Landscape Review Committee Hybrid In-Person & ZOOM Online Meeting Wednesday, November 15, 2023 - 12:00 PM

DATE:November 15, 2023TO:Landscape Review Committee MembersFROM:Adam Tate, Associate PlannerSUBJECT:Tree Removal Application (L 47-23)

DATE:November 15, 2023TO:Landscape Review Committee MembersFROM:Tom Schauer, Senior PlannerSUBJECT:Landscape Plan Review Application (L 48-23)

DECISION, CONDITIONS, FINDINGS OF FACT AND CONCLUSIONARY FINDINGS FOR THE APPROVAL OF A LANDSCAPE PLAN REVIEW FOR PROPERTY AT 455 NE IRVINE STREET

Figure 2. Site Photos.

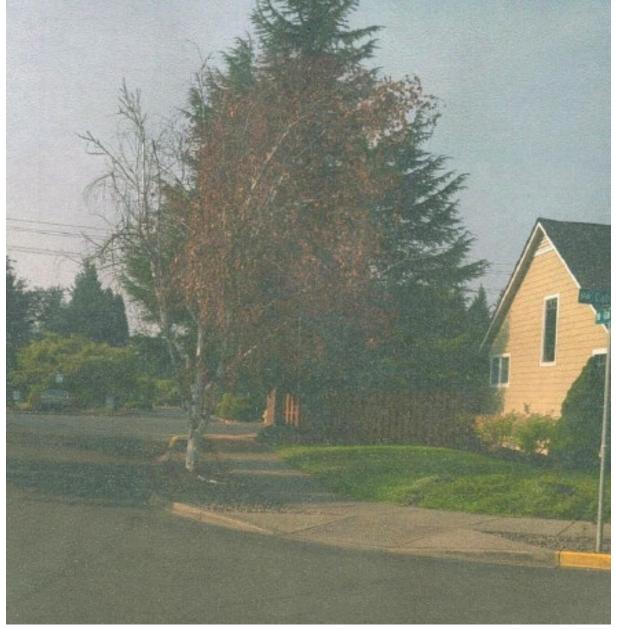
This proceeding is a review by the Landscape Review Committee of a street tree removal application *(Attachment 1)* for one (1) deciduous street tree, a 8 inch DBH Birch tree, on the west side of NW Oak Ridge Drive at the corner with Cabernet Court. The tree is dying from a Bronze Birch Borer Beetle infestation according to the arborist's report and appears to be losing leaves and limbs. However when Public Works went to inspect the tree it had already been removed making it impossible to fully verify the findings of the applicant and arborist. *See Figure 1 for Vicinity Map. See Figure 2 for Site Photos.* Note that the first site photo was provided by the applicant. Staff finding this photo rather poor, then took a screenshot from Google Street View for the second site photo which shows the tree in much better detail.

Criterion "A" is met as the tree is in poor health due to the insect infestation.

- **5.** The applicant shall replace the tree with one (1) new tree planted in the planter strip slightly farther away from the mailboxes. The new tree shall be selected from the recommended street tree list.

Figure 4A. Street View from 5th Street (After Tree Removal)

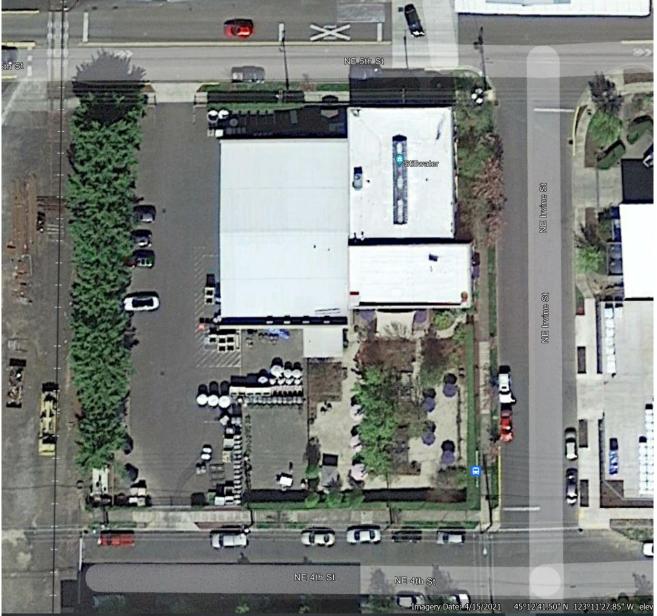
There was previously a row of trees along the west property line abutting the railroad tracks and the adjacent tax lot owned by the railroad. **See Figure 3.** The property owner removed those trees, and the area is currently being used for equipment storage. **See Figure 4.**

The landscape plan doesn't clearly/accurately identify the location of exiting landscaping on the site. The majority of the site has an evergreen hedge between the parking lot area and 5th Street and between the parking lot area and 4th Street. There is a gap in the hedge generally in the location south of parking space 34 shown on the plan.

- 3. Restore evergreen hedge where gap is present in vicinity south of parking space 34.
- 4. Once approved, the applicant shall install landscaping as shown on the revised and approved landscape plans addressing the items above. Landscaping shall be installed prior to final inspection for the building permit, or the applicant shall provide financial surety as specified in the Zoning Ordinance, and landscaping shall be completed no later than 6 month from final inspection.

Figure 4B. Street View from 4th Street (After Tree Removal)

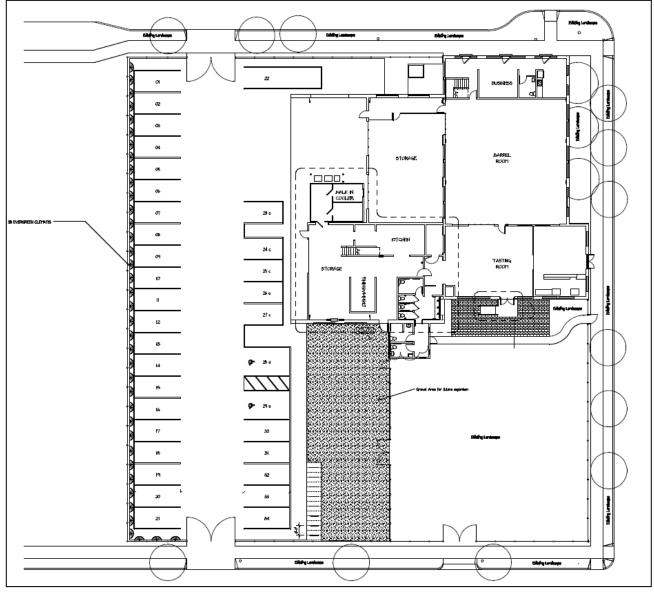
The hedge also wraps around the existing outdoor area at the southeast corner of the property. There are also street trees in some of the planting strips along the frontage of the property, but the landscape plan doesn't accurately depict the location of those existing trees. In addition to other differences, there are no street trees north of parking space 1 or south of parking space 21.

- d. Unless there is a conflict with the railroad or utilities, add street trees to the planter strip north of space 1 and south of space 21, or south of space 34. There is an existing tree north of space 22. (The current plan shows existing trees in these locations which aren't present). The specified street trees shall be selected from the City's street tree list from trees suitable for planting under overhead utilities.

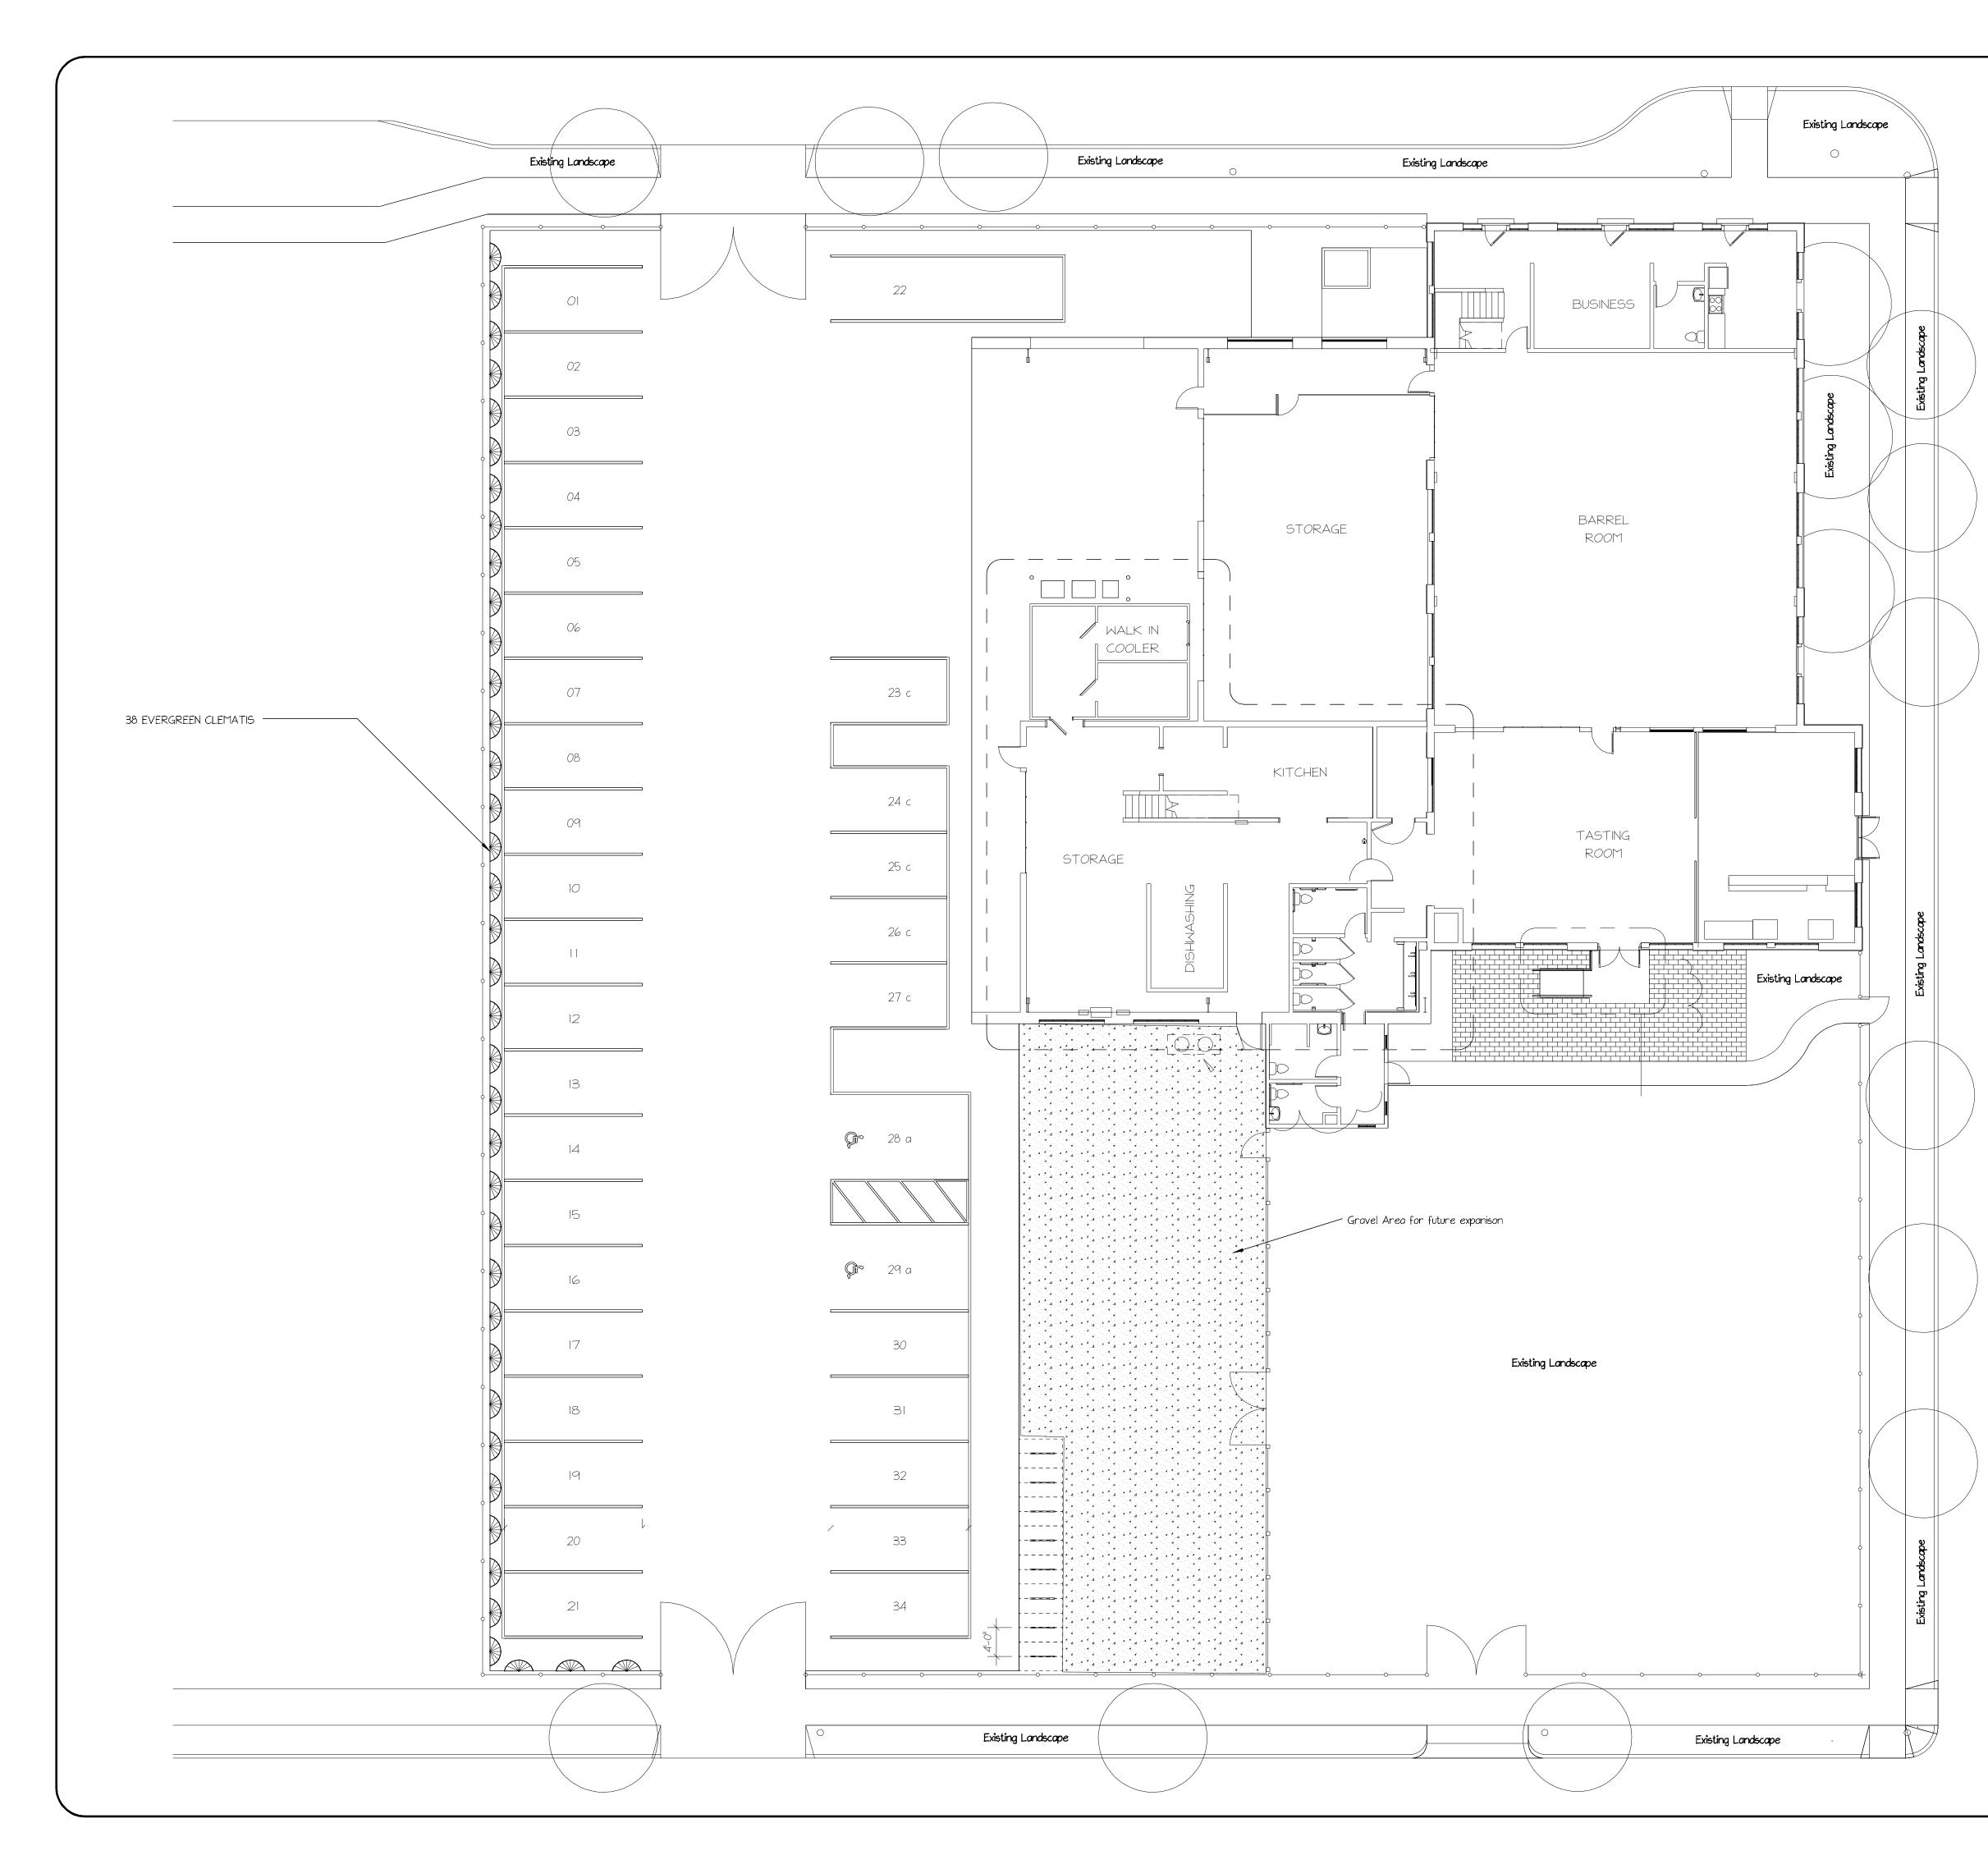
The applicant's site plan and landscape plan show the requested/required 34 parking spaces. **See** *Figure 5.* The Zoning Ordinance specifies that a minimum of 65% of spaces must be standard sized spaces, and others are the required ADA spaces and a portion of spaces can be compact sized spaces. The site plan shows 79% of the spaces (27) are standard spaces. To achieve a double-loaded parking aisle that provides the minimum 34 off-street parking spaces, the remaining width west of the parking spaces is limited in width. The applicant is proposing screening along the west property line with 38 evergreen clematis.

As addressed in the criteria below, parking lots are typically required to be broken up with landscape islands and end islands containing trees to provide shading of paved areas. These are typically required to be distributed at approximately every 6 to 10 spaces for certain specified uses. It doesn't appear that full length end islands or a full-length landscape island at the midpoint of the parking area could be provided without reducing the off-street parking below the minimum requirement. However, trees could potentially be incorporated by reducing the size of some of the westerly parking spaces to 16-foot long compact spaces rather than 19-foot long standard spaces to provide additional planting area for trees, which would appear to provide 5 or 6 feet deep planting areas at those locations. This could be done at each end and the middle, and there would still be sufficient standard-sized parking spaces to mee the 65% minimum requirement. In addition, unless there are conflicts with the proximity to the railroad or other conflicts, street trees could potentially be added to the planter strips to the north and south of the parking lot.

- 1. The applicant shall submit a revised landscape plan to the Planning Departure for review and approval, incorporating applicable revisions described in conditions below.

- **a.** Show the accurate location of the existing landscaping, hedges, and street trees.
 - **b.** Show the delineation of the existing and proposed paved and landscaped areas, including existing and proposed curbing and wheel stops.

- c. Reduce the depth of parking spaces 1, 8, 14, and 21 from 19 feet standard spaces to 16 feet compact spaces and add trees at the widened westerly planting area at the end of these spaces.

- e. Identify any proposed exterior lighting and method of shielding/downcast lighting.
- **2.** The landscape plan indicates "existing irrigation is in place." Clarify the nature of existing irrigation.
